CONTENTS

APPENDIX 3

3A ANSWERS TO QUESTIONS

SACRAMENTO MUNICIPAL UTILITY DISTRICT

FIGURE 3A.2-1
 FUEL TEMPERATURE VERSUS TOTAL FUEL
 VOLUME FRACTION FOR EQUILIBRIUM
 CYCLE AT END OF LIFE

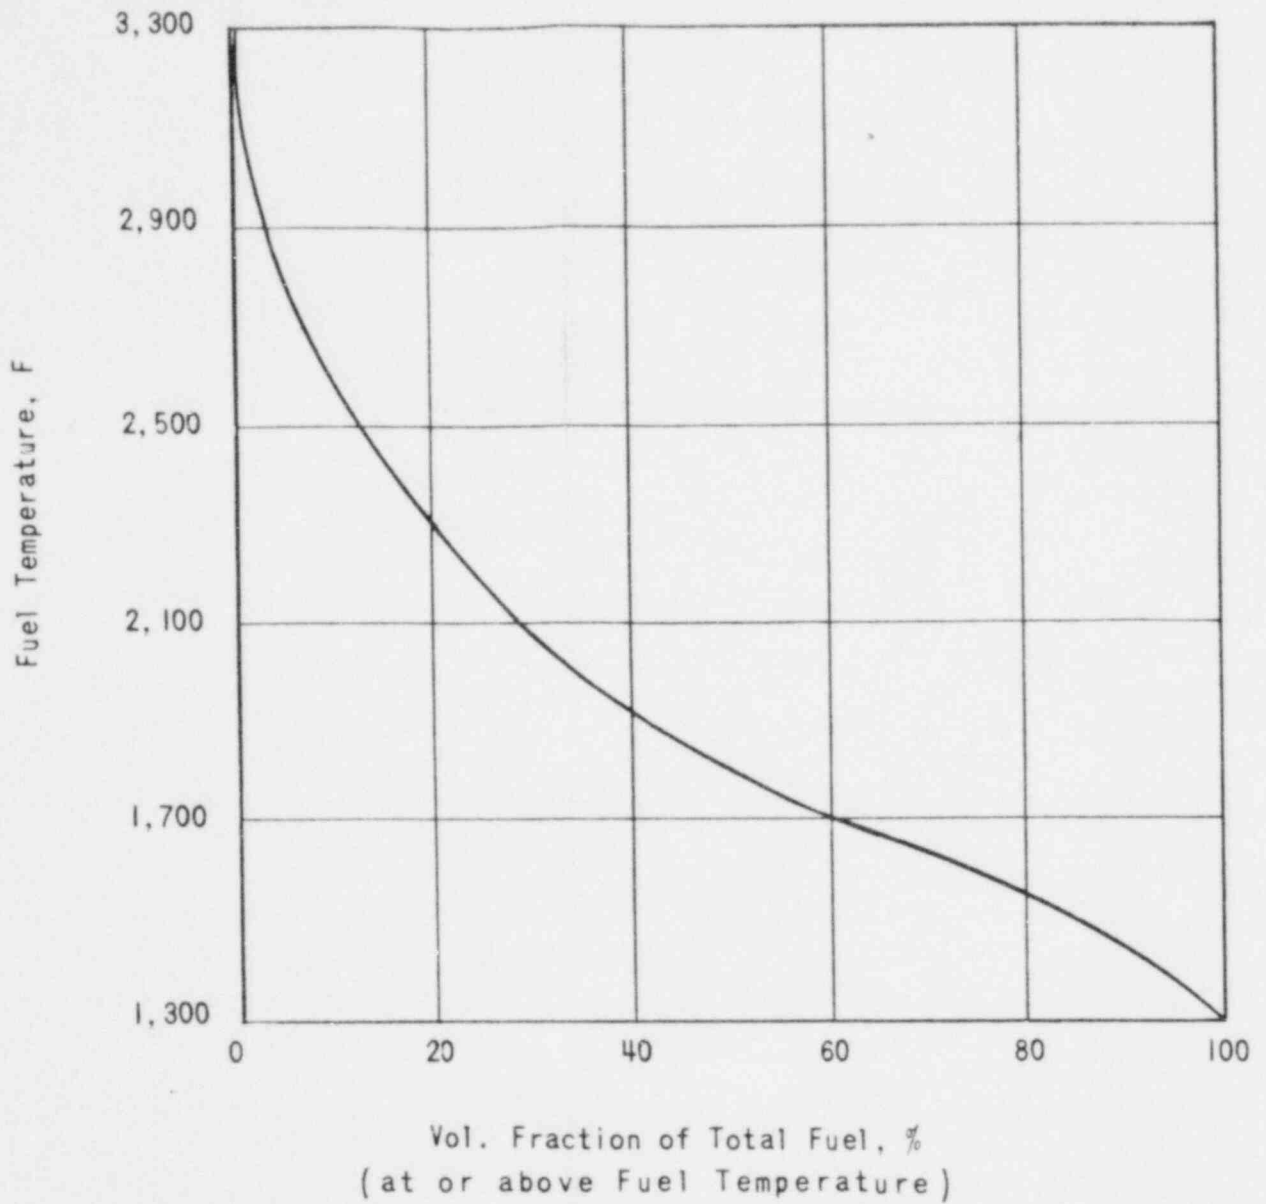
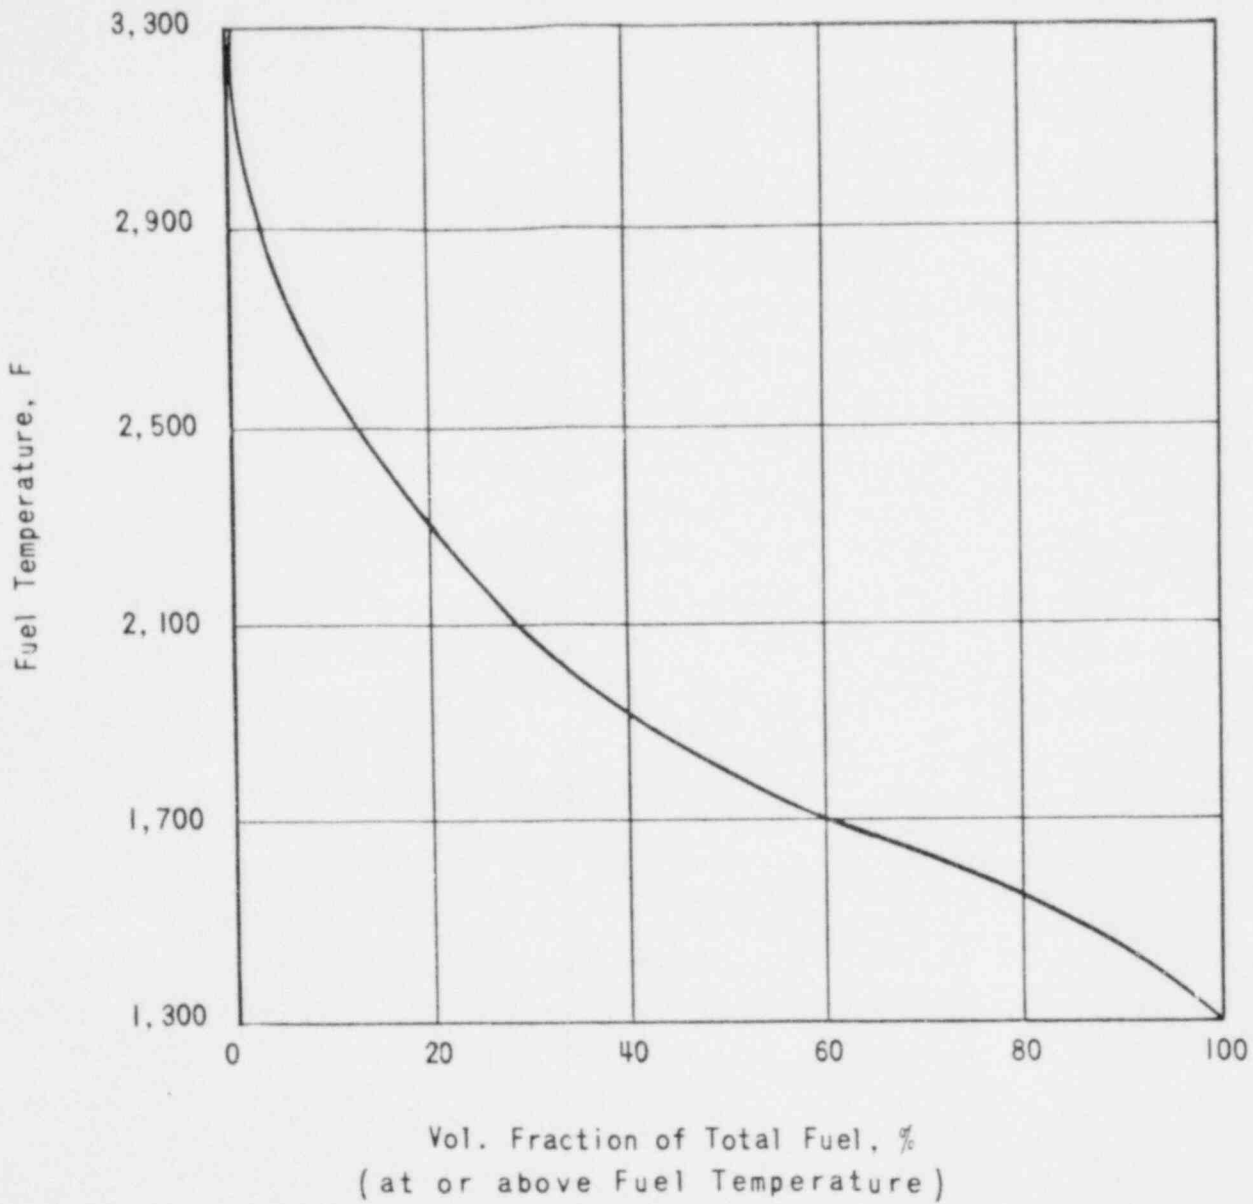
Provide a plot of fuel temperature versus the volumetric fraction of the total fuel at that temperature in the core at end-of-life conditions. Describe the method of calculation, state all assumptions, and provide typical radial pin profiles and the gross peaking factors used.

A plot of fuel temperature versus the volume fraction is shown in Figure 3A.2-1 at 100 percent power. A typical fuel cycle power distribution for equilibrium cycle, end-of-life conditions was used. The bundle average powers shown in Figure 3A.2-1 were used to obtain the fuel rod heat rates. A symmetrical cosine axial power distribution with a 1.5 max/avg value as shown in PSAR Figure 3.2-11 was used to predict the axial distribution. It was assumed that 97.3 percent of the power is generated in the fuel. The fuel rods were divided into 14 axial and 10 radial segments to obtain the temperature distribution for this analysis. The heat rate for every fuel rod in the core was increased by a local peaking factor of 1.05 to account for uncertainties in the calculation of local peaks. This has the bulk effect of raising reactor power to 105 percent.

The fuel temperature calculation model is outlined in PSAR Section 3.2.3.2.4g. The fuel conductivity curve identified as GEAP-4624 in Figure 3.2-49 was used to provide conservative values for fuel conductivity in the hottest regions of the core at the end of life. The maximum powers occurred in fuel assemblies with one and two cycles of operation as shown in Figure 3A.2-2, and the assemblies with the highest burnup did not exceed 1.043 times the average power for the case analyzed. The calculation shown in Figure 3A-1 was made by grouping all segments of fuel by temperature and assigning a conservative value for the fuel-to-clad heat transfer coefficient for typical end-of-life conditions. This is illustrated by the temperature profiles shown in Figure 3A.2-3. Typical fuel-to-clad heat transfer coefficients used were 280 and 480 Btu/hr-ft²-F for 6 and 10 kw/ft heat rates respectively. The corresponding beginning-of-life coefficients are about 630 and 940 Btu/hr-ft²-F at 6 and 10 kw/ft heat rates.

The temperature profiles are based on a uniform heat generation rate in the fuel. This is a conservative assumption since a larger fraction of power is generated at the outer periphery of the fuel than in the center region.

FIGURE 3A.4-1
INTERNALS VENT VALVE

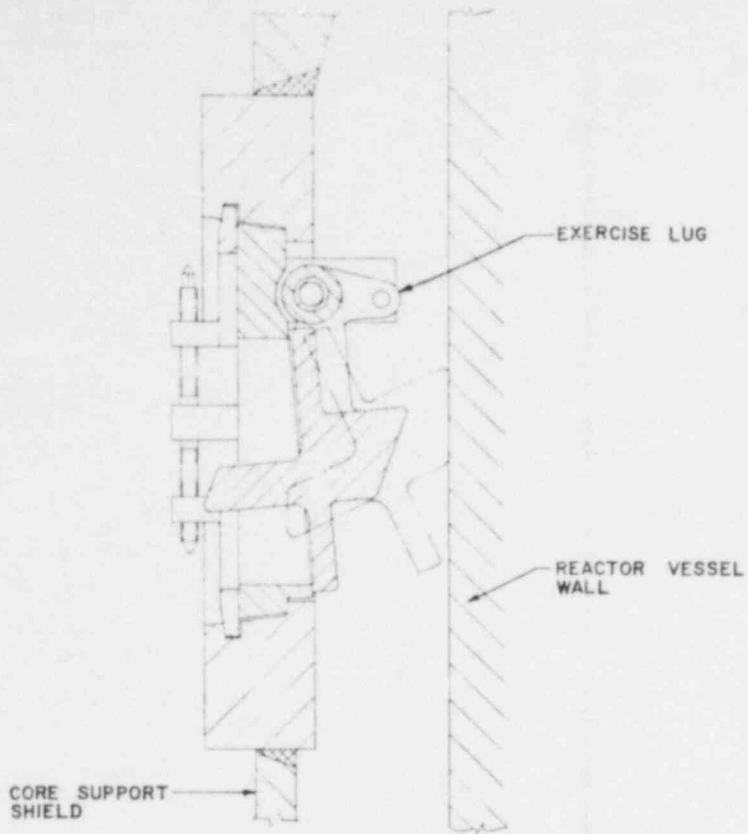
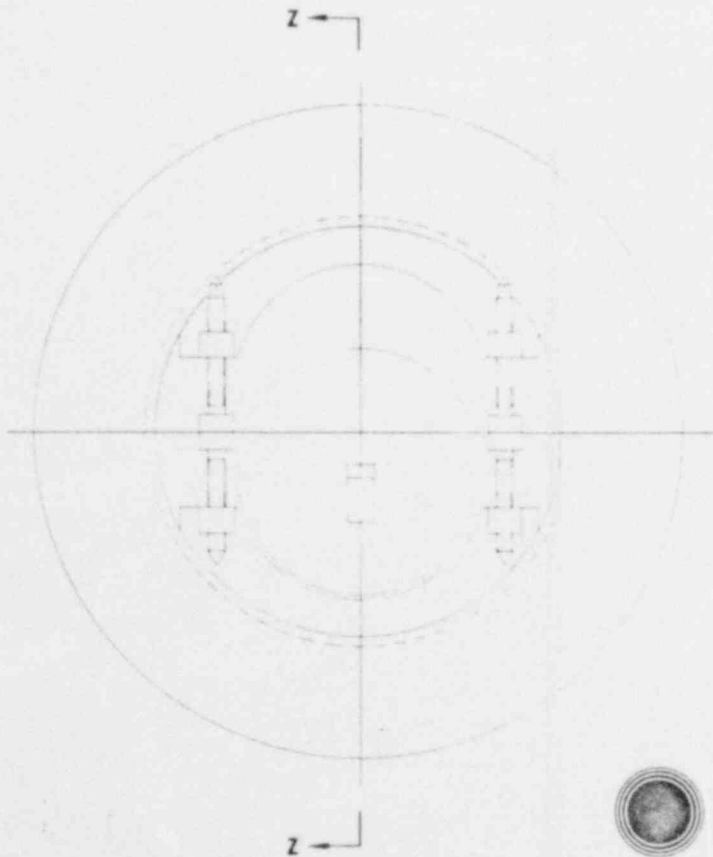
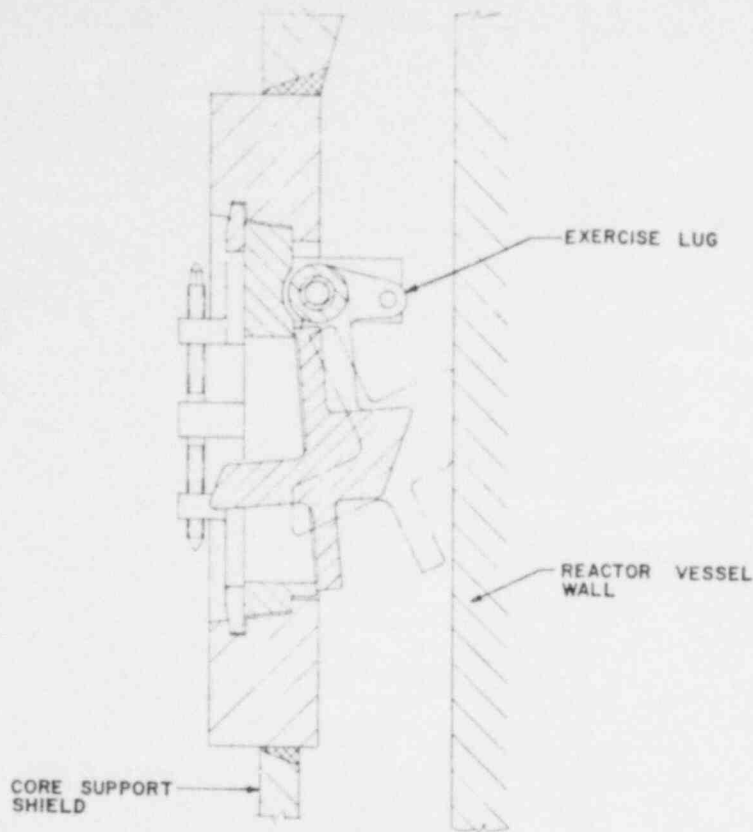
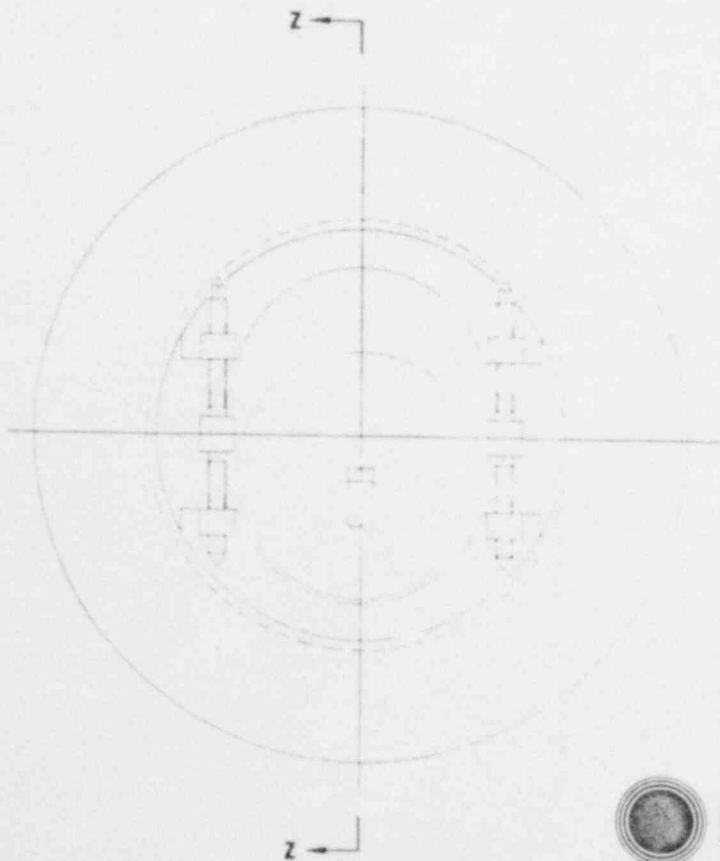
Describe the preliminary design of the means to prevent a vapor lock in the hot leg after an accident which we understand to be check valves located in the core barrel.

- 3A.4.1 Discuss alternate solutions including rearrangement of the primary system.
- 3A.4.2 Describe the assumptions used in calculating the required capacity, number and size of the valves and the redundancy in number and capacity to be provided.
- 3A.4.3 Indicate the location of the valves in the core barrel and the means provided to remove, test, and inspect them.
- 3A.4.4 Discuss the hinge design with respect to failure of components and availability for inspection.
- 3A.4.5 Indicate the consequences of loss of a valve from the standpoint of detecting the occurrence, damage to the core from flow bypass and physical damage potential of the loose valve.

The preliminary design of this valve is shown in Figure 3A.4-1. The valve disc hangs closed in its natural position. A flat, stainless steel seat inclined 5 degrees from vertical insures

against flow from the annulus to the upper plenum chamber assembly. In the event of an accident, the reverse pressure drop will open the valve. At all times during normal reactor operation the pressure in the annulus on the outside of the core support shield is greater than the pressure in the upper plenum chamber on the inside of the core support shield. Accordingly, the vent valve will be held closed during normal operation. With four reactor coolant pumps operating, the pressure differential is 42 psi resulting in a several thousand pound closing force on the vent valve.

Under accident conditions the valve will begin to open when a pressure differential in a direction opposite to the normal pressure differential of about 0.3 psi develops. At this point the opening force on the valve counteracts the natural closing force of the valve. With a pressure differential of no greater than 1.5 psi, the valve would be fully open. With this pressure differential the water level in the core would be at about the top of the core. In order for the core to be half-uncovered, assuming solid water in the bottom half of the core, a pressure differential of 3.7 psi would have to be developed. This would provide an opening force of about 3 times that required to open the valve completely. This is a conservative limit since it assumes equal density in the core and the annulus surrounding the core. The hot, steam-water mixture in the core will have a density much less than that of the cold water in the annulus, and somewhat greater pressure differentials could be tolerated before the core is more than half-uncovered.

FIGURE 3A.14-1
 ATTENUATION OF NEUTRON FLUX ABOVE 0.82 MEV
 BETWEEN CORE EDGE AND VESSEL WALL

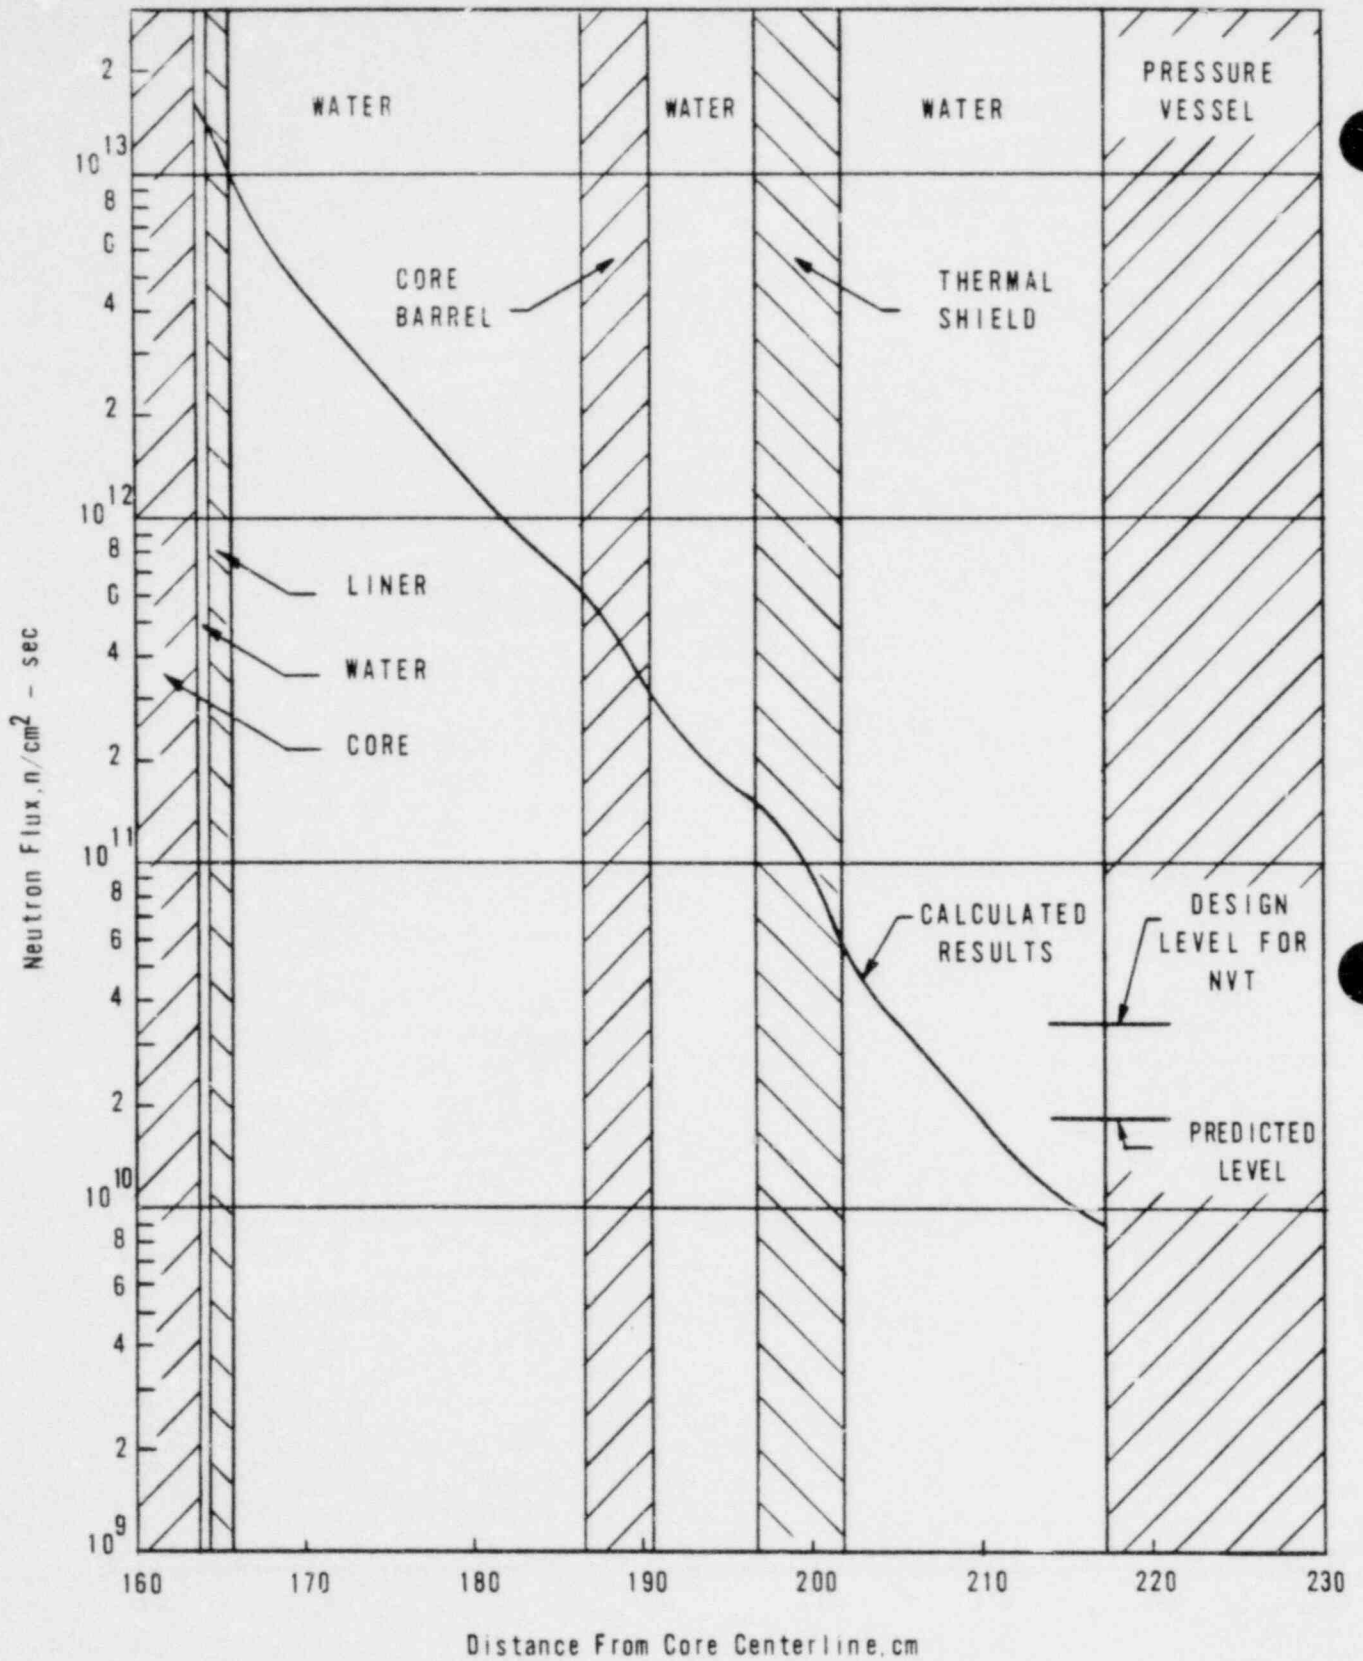
Discuss your calculational model and indicate the error band on the fast neutron flux ($E_n = 1.0$ Mev) at the pressure vessel inner surface which was calculated to be 3.4×10^{10} (n/cm²-sec). Include in the discussion:

- (a) How azimuthal variations are treated in the analysis and relate these to the azimuthal placement of the surveillance specimens.
- (b) The uncertainties associated with the attenuation factor of $6.0 \times 10^{13} / 3.4 \times 10^{19}$ or 1760 and relate their potential consequences to higher values of NDTT for the pressure vessel wall.
- (c) The maximum fast neutron exposure (see pg. 4.1-8) is indicated to be 3.0×10^{19} (n/cm²) or, at 80% load factor, 1.9×10^{10} (n/cm²-sec). Explain the relationship between this design limit and the data given in Table 3.3-7 of the PSAR with respect to the factor of 2 conservatism indicated on page 3.2-14 of the PSAR.

Figure 3A.14-1 shows the attenuation of the neutron flux above 0.82 Mev between the core and the reactor vessel wall as computed by the TOPIC program. The fluxes as shown are based on an estimated lifetime average power density at the core edge of 36.5 watts/cc. This includes a 1.3 estimated axial power peaking factor at the outer edge of the core, averaged over plant life. To account for differences between TOPIC calculations and thermal flux measurements in the LIDO pool (see page 3.2-13 of the PSAR), a scaling factor of 2 was applied to the calculated flux values at the vessel wall. This results in a flux level of 1.8×10^{10} n/cm²-sec which is the predicted flux on the vessel wall including axial power peaking, averaged over the life of the plant.

To obtain a design value for the nvt on the reactor vessel the predicted flux at the vessel wall was modified to include the following conservatisms.

1. Radial power peaking factor. The maximum power density at the outer edge of the core, averaged over the life of the plant, is estimated to be 36.5 watts/cc. The power density at the core edge at the end of each core cycle, resulting from radial power shifting, is estimated to be 53 watts/cc. For design purposes the fluxes were increased by a ratio of 53/36.5 to reflect the transient rather than the average power density, resulting in a safety factor of 1.45.
2. Axial power peaking factor. The axial power peaking factor at the outer edge of the core, averaged over the life of the plant, is estimated to be 1.3. The maximum axial peaking at any time during life is 1.7. To arrive at a design value the fluxes were normalized to the maximum value of 1.7 instead of the expected average of 1.3. This provides a safety factor of 1.3.
